GE Hitachi Nuclear Energy

Subject: Response to Portion of NRC Request for Additional Information Letter No. 229 Related to ESBWR Design Certification Application - Emergency Core Cooling Systems - RAI Numbers 6.3-84 and 6.3-86

**Response to Portion of NRC Request for
Additional Information Letter No. 229
Related to ESBWR Design Certification Application**

RAI Numbers 6.3-84 and 6.3-86

Figure 6.3-84-1. GDCS Flows into the RPV for ICDL Break with Failure of one GDCS Check Valve

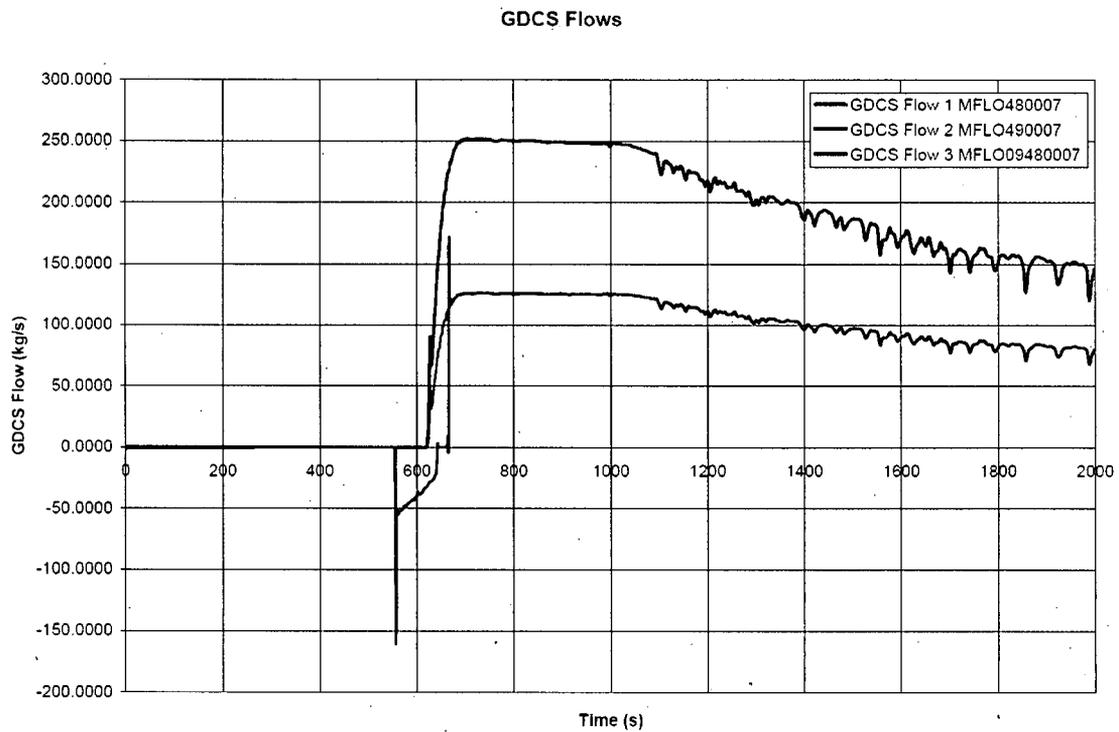
In DCD Revision 5, Tier 2, Section 6.3.3.3, where single-failure is addressed, please include discussion using TRACG to demonstrate that the core will be covered with a single failure assumption if one GDCS check valve failed to close when the RPV pressure is higher than that of GDCS.

Consistent with DCD Tier 2, Revision 5, Subsection 6.3.3.7.9, the ICDL break is considered to be the most limiting core level case. Figure 6.3-84-1 shows the GDCS pipe flows during the TRACG run. It can be seen that there is the expected backflow through the GDCS line at approximately [[]] seconds when the GDCS injection valves open. The other GDCS lines show no sign of reverse flow indicating that the check valves on these lines are operating successfully. Once RPV pressure has equalized with containment, forward GDCS flow resumes and begins to fill the RPV.
